According to provisions of 10 CFR 2.206, I hereby petition the NRC to perform *de novo* reviews of ballooning (swelling) and rupture models used in licensees' loss-of-coolant accident analyses required by 10 CFR 50.46, and further to require licensees to incorporate any modifications needed to obtain NRC approval and then use only such models that have been so reviewed and approved by the NRC in all such licensing analyses.

**The Issue**

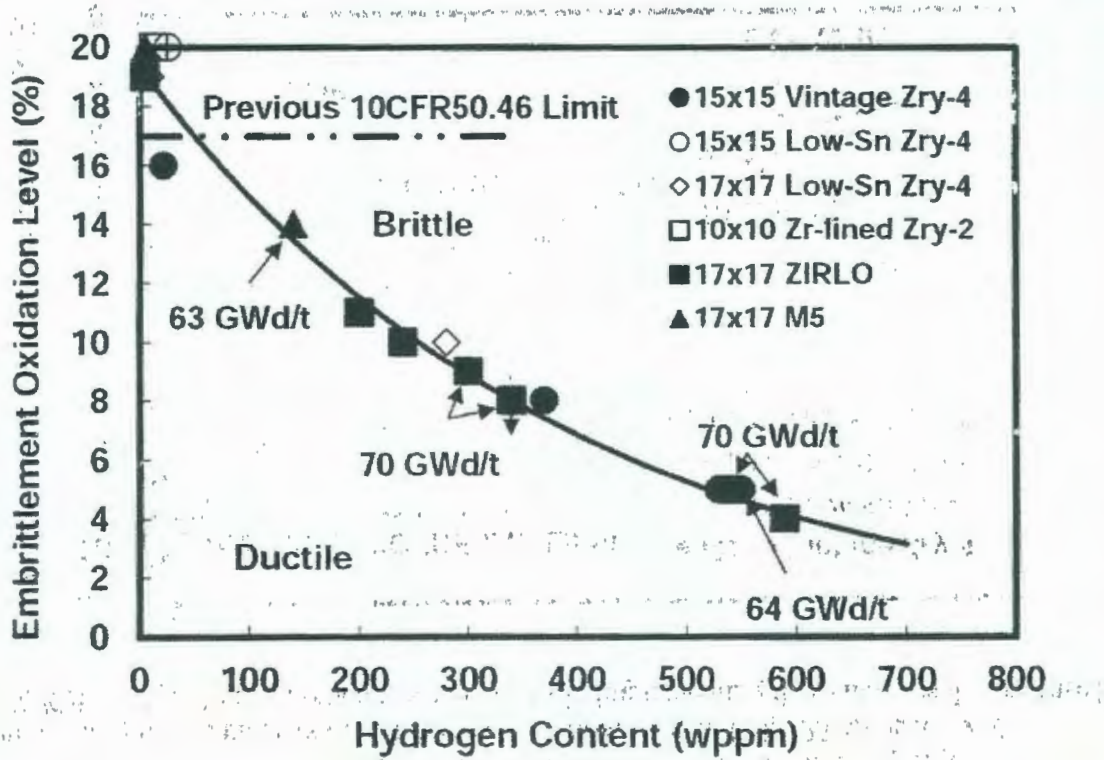
Recent research results show that the limiting oxidation level for high-burnup fuel will be far below the 17 percent limit prescribed by 10 CFR 50.46 as seen in the following figure (unnumbered figure on page xxxii of the Executive Summary and Fig. 25 on page 59 of NUREG/CR-7219). Relaxed schedules and delays in implementing these new results are based

on a safety assessment and audit which confirmed that sufficient safety margin exists for operating reactors and determined that immediate regulatory action was not required (Clifford to Ruland, February 10, 2012, ML12041A078). This assessment was based on industry calculations with models that may be flawed because of inadequate ballooning and rupture models.

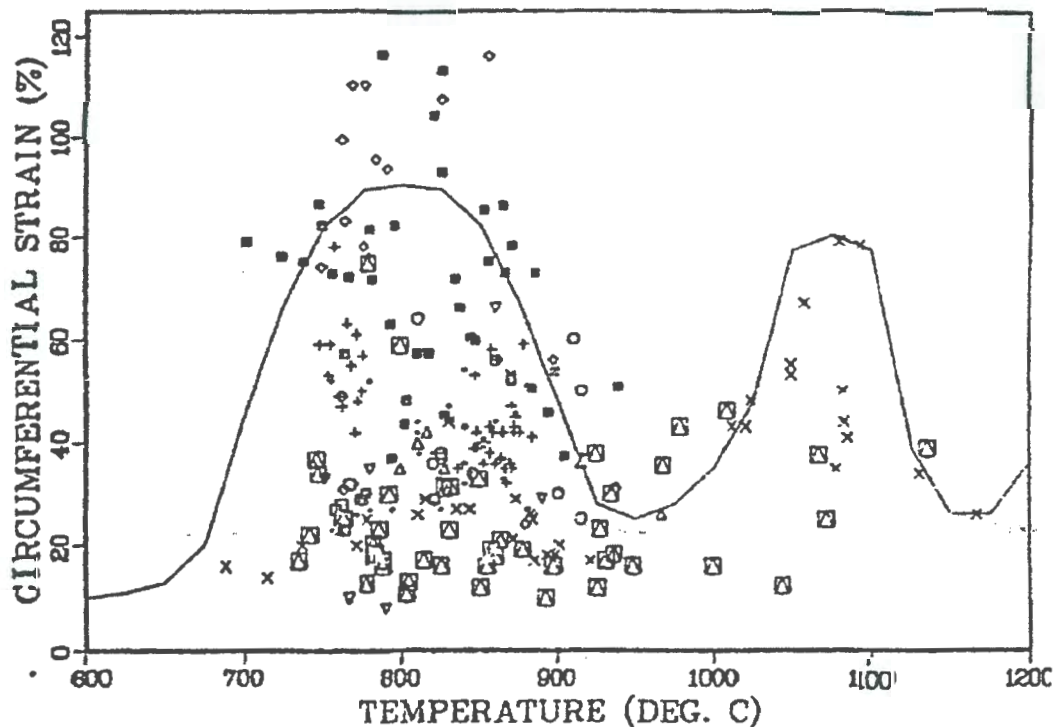
In light of recent research results, the ballooning and rupture models used in licensing analyses to calculate ECR are probably non-conservative. The basis for this statement can be explained with the following figure from NUREG-0630. This figure shows the size of the balloons (larger balloons have thinner walls) as a function of rupture temperature for fresh or low-burnup Zircaloy. There are two peaks: alpha-phase cladding on the left and beta-phase cladding on the right. The valley in the middle is in the mixed-phase region. It was previously believed that fill pressures could be engineered such that rupture would occur in the mixed-phase valley and therefore balloons would be relatively small. Most or all current ballooning and rupture models used in licensing predict relatively small balloons. This was not considered a concern by NRC because ECR was seldom if ever limiting and a more critical review seemed unnecessary.

The second finding is that the peaks-and-valley character of balloon size, as shown in the above figure, shifts along the temperature axis with the addition of niobium to zirconium in the more modern ZIRLO and M5 cladding materials. Although we now know that niobium causes a shift, there are not enough data to define the new peaks and valley for ZIRLO and M5 such that one could claim that ruptures only occurred in the valley.

Finally, one should recognize that the curve drawn through the scattered data in the above figure is a best estimate and was not intended as a conservative representation of the data. As an author of that report, I know that many of the tests that resulted in smaller balloon sizes had atypical test conditions that biased their results. Therefore, we drew the best-estimate curve through the larger balloon sizes. Thus, any model that predicts ballooning strains less than about 90%, based on the above figure, should be suspected of being non-conservative.

It is well known that rupture results from a plastic instability that is set off by local temperature hot spots. There are many causes of local temperature variations that lead to the unpredictable character of the rupture process, as seen in the large data scatter in the above figure. Mechanistic models cannot represent the stochastic nature of this process. Therefore a statistical approach, which represents all of the data without favoring strains in the mixed-phase valley, is probably needed and should provide some modest conservatism of the ensemble of data.
